Bath City Centre Consultation - Walk Ride Bath (WRB) Response

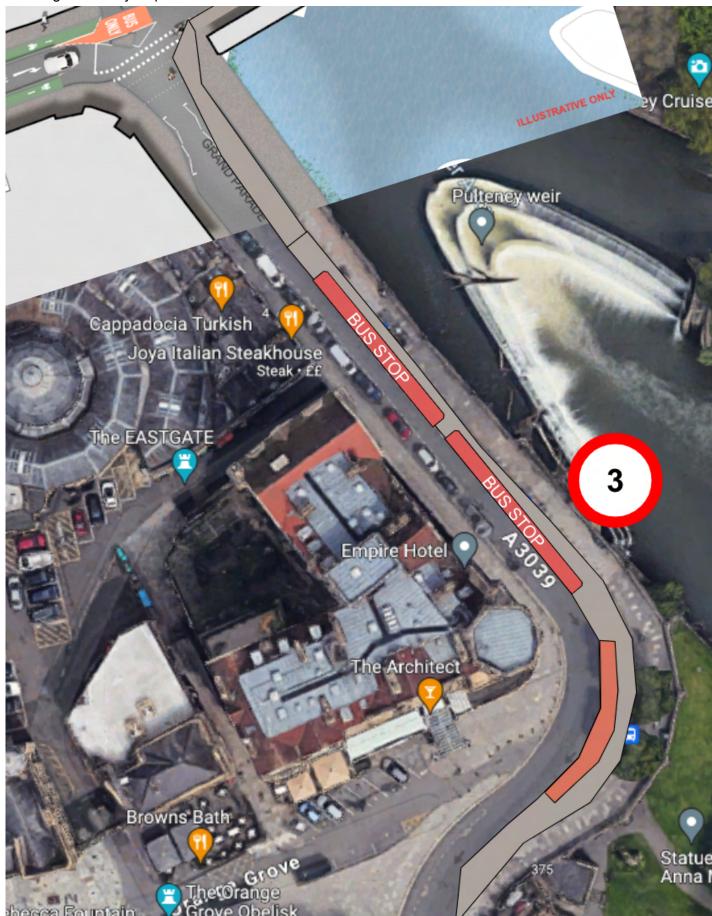
3. Grand Parade: Widen the promenade narrowing the carriageway to 3m integrating bus stops while preventing the poor overtaking interaction between cyclists and drivers while creating a better transition

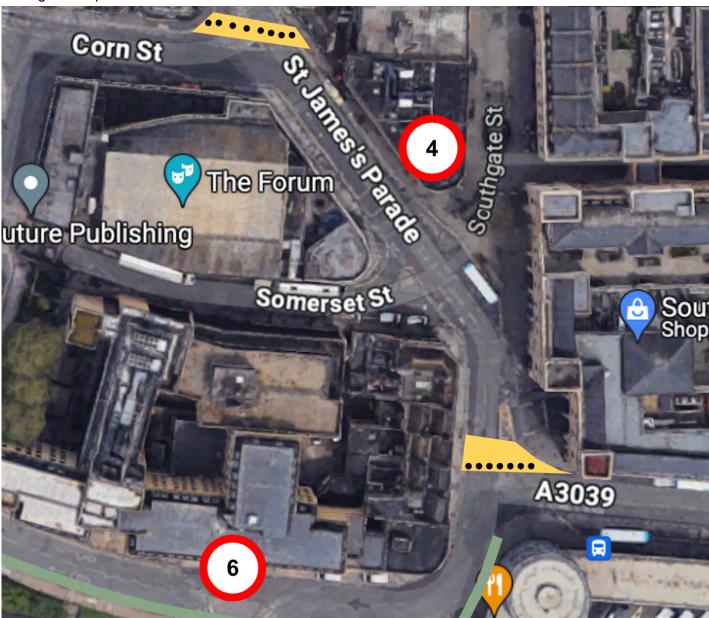
4. Corn St/Southgate St: Block vehicular access from Corn St to St James Parade and Southgate St to Dorchester St making Southgate St two way. Provides an opportunity to narrow Southgate St to better connect the Southgate area with Quays via Somerset St. This also removes buses being delayed by

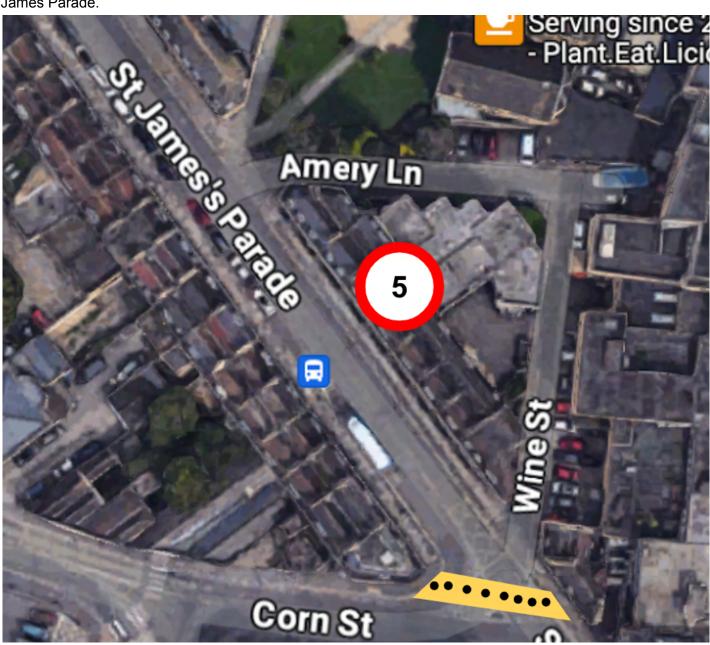
5. St James Parade: Make it one way with cycle contraflow beyond Amery Lane, using Wine St as a loop creating opportunity for 15+ Blue Badge holders parking bays on the north side of this section of St

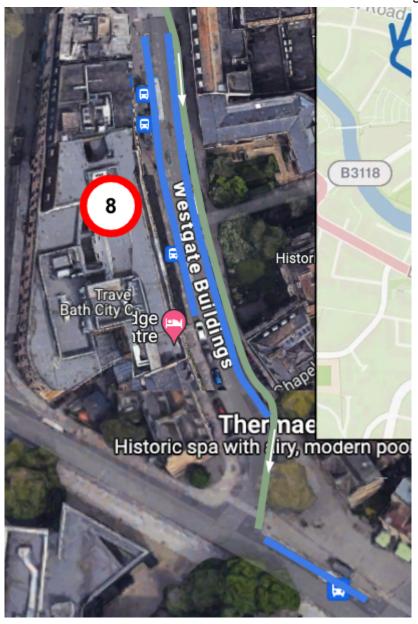
6. Churchill Bridge: Add bus/taxi gate to prevent east-bound traffic along Dorchester St. Add drop of laybys on Churchill Bridge.

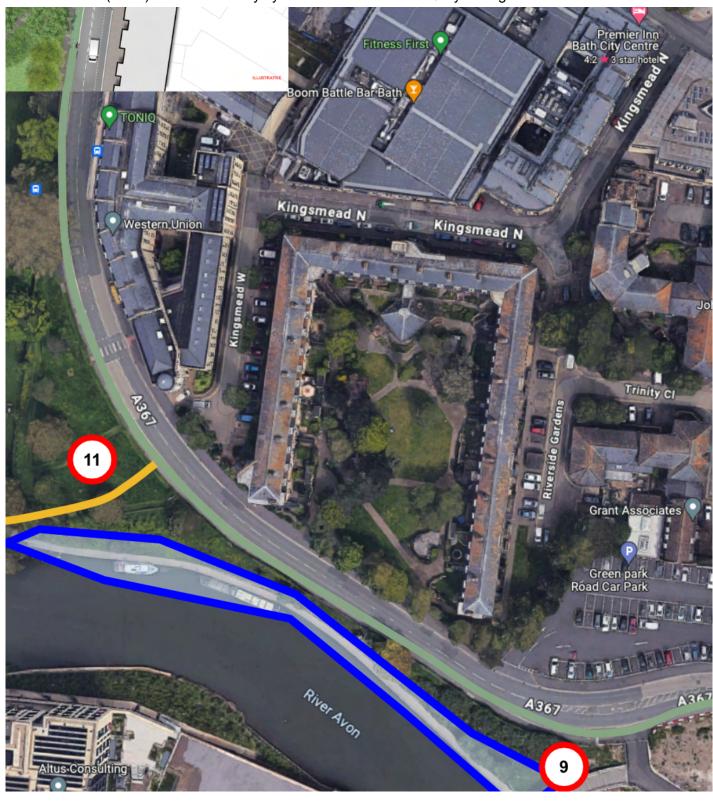
8. Westgate Buildings: Close bus stops, float parking, add cycle contraflow, and add Blue Badge holders parking spaces where bus stops were. Move bus stops to Avon St removing through buses from Seven

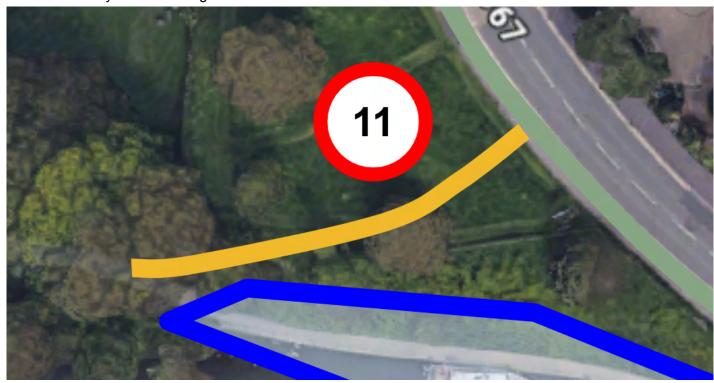
9. Green Park Rd (A367): Extend two way cycle track to connect to Quays Bridge

10. Quays Bridge: Create cycle link to Avon Street

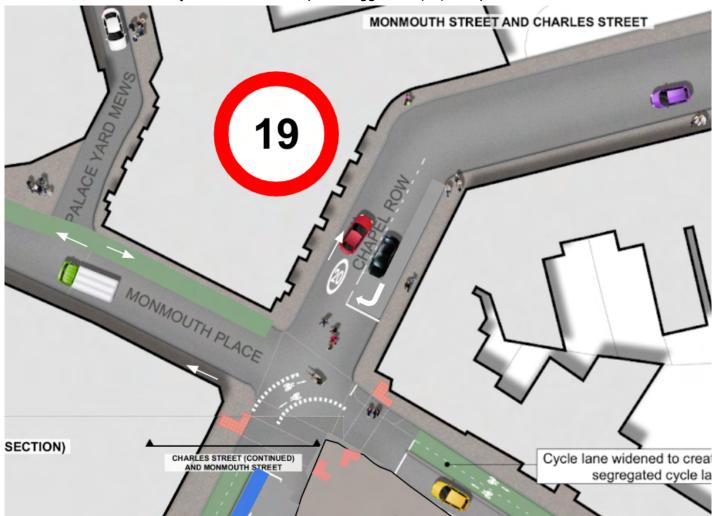
16. Monmouth Place/Charlotte St: Tighten junction significantly creating a safer junction for crossing by pedestrians and better junction interaction for cyclists.

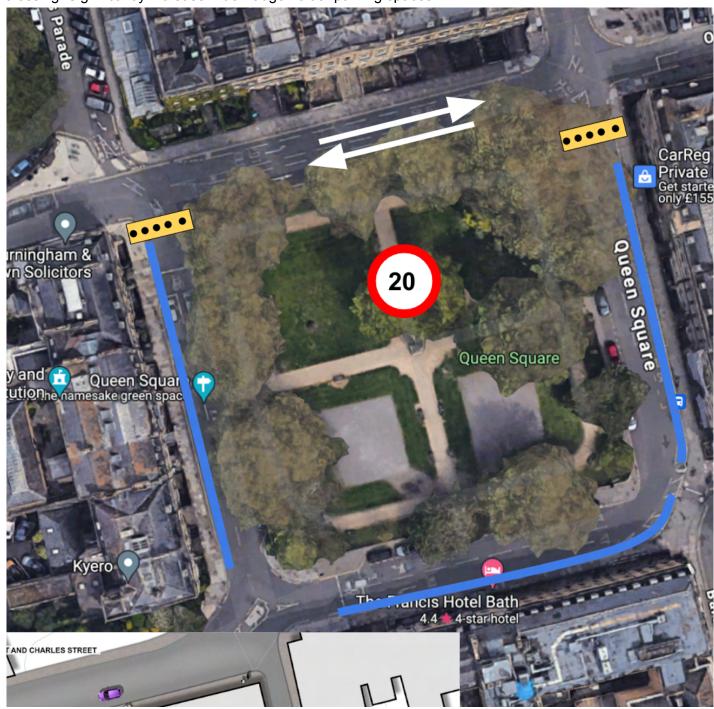
19. Monmouth St/Charles St Junction: Left turn only from Chapel Row, except cycles. Remove the left turn from Monmouth Street. Only viable if Queen Square suggestion (20) is implemented.

Improved Circulation Plan prioritising buses and pedestrians

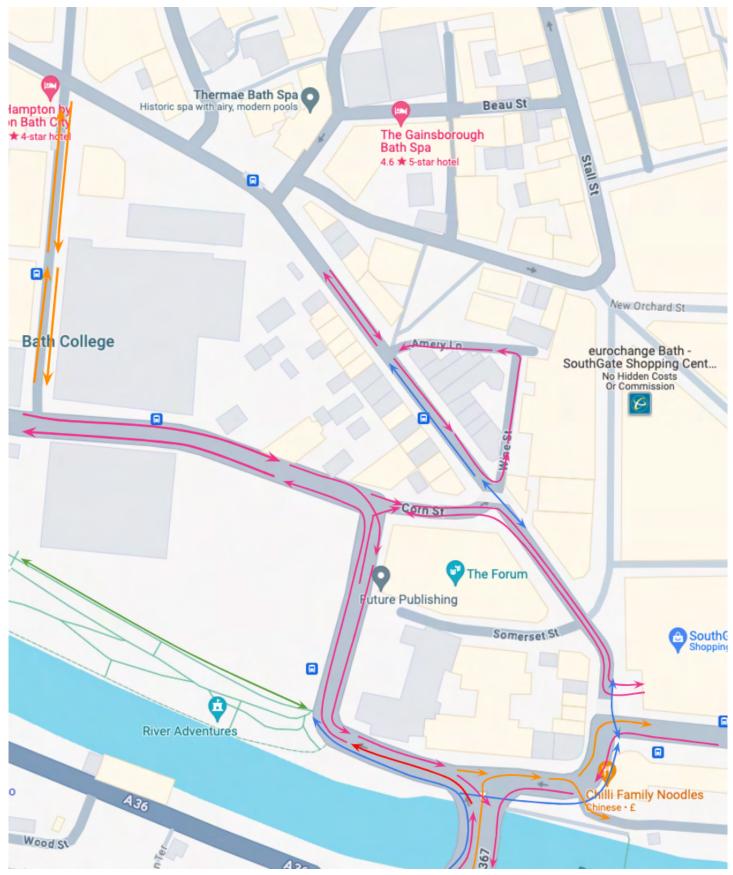
The proposed bus gate on St James Parade does remove private through traffic from the Kingsmead Square area. However this still creates poor interaction with the Southgate Car Park entrance while still allowing private cars to access the train station via Dorchester St creating unnecessary delays for bus services. It

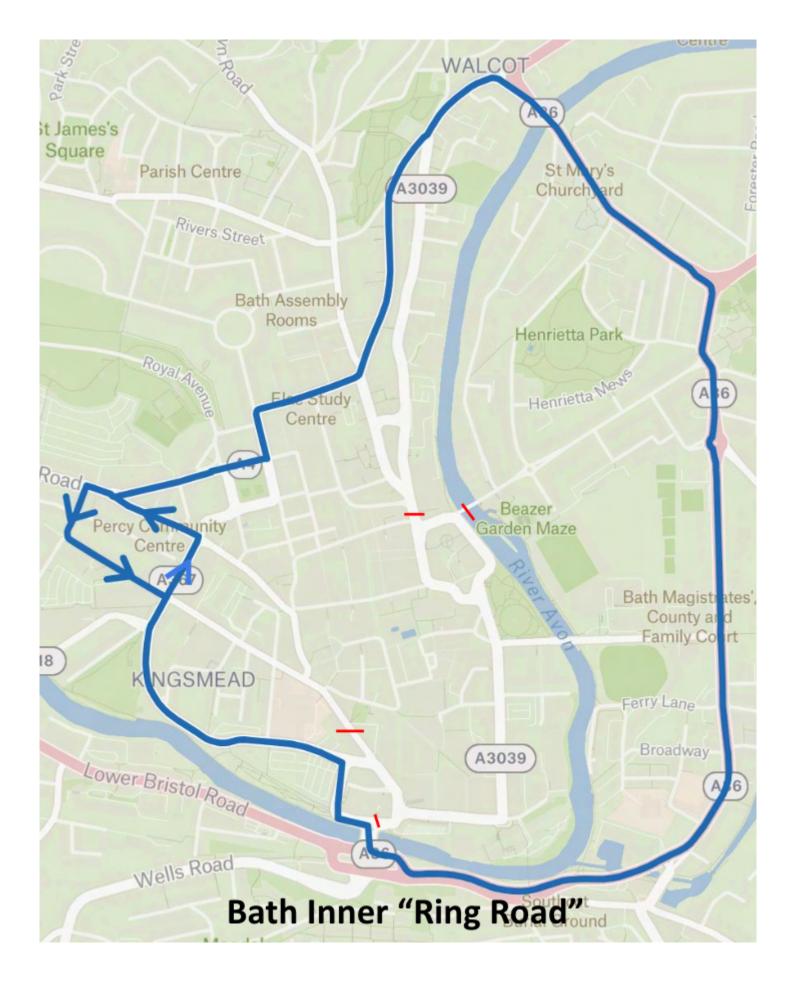
Our proposed changes to Queen Square would achieve a number of objectives:

- LTN 1/20 compliance for cycling on Chapel Row as mixed traffic would be viable.
- Remove bottlenecks at Gay Street & George Street as only a controlled pedestrian crossing at the corner of Gay Street/Queen Square would be required.
- Define the inner city ring road to support the delivery of the City Centre Liveable Neighbourhoods as set out in the JtNZ report.
- Prioritise routes through the city centre for bus services.
- Create a high value low traffic public park/realm similar to what was achieved at Queen Square in Bristol.

Seven Dials

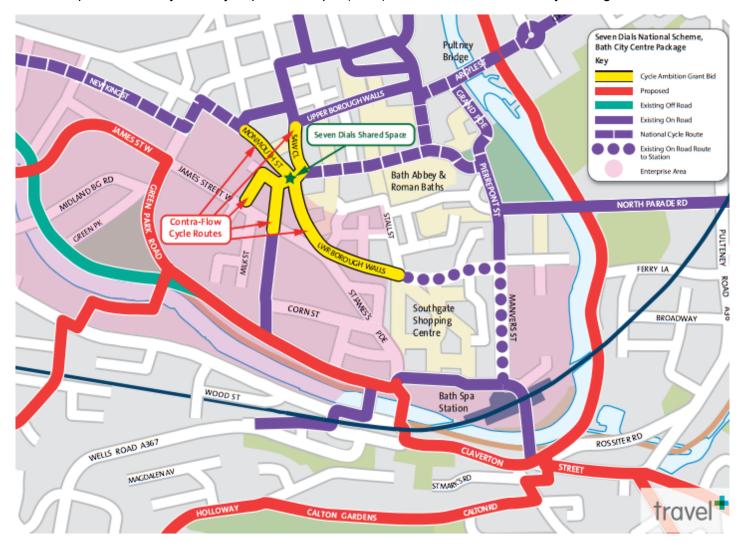
The Cycle City Ambition Grant for Seven Dials 'Shared Space' failed to deliver:

- A cycle contraflow on Monmouth Place
- A contraflow on Westgate Buildings
- A space usable by Visually Impaired People (VIPs) for whom this is effectively .a no-go area.
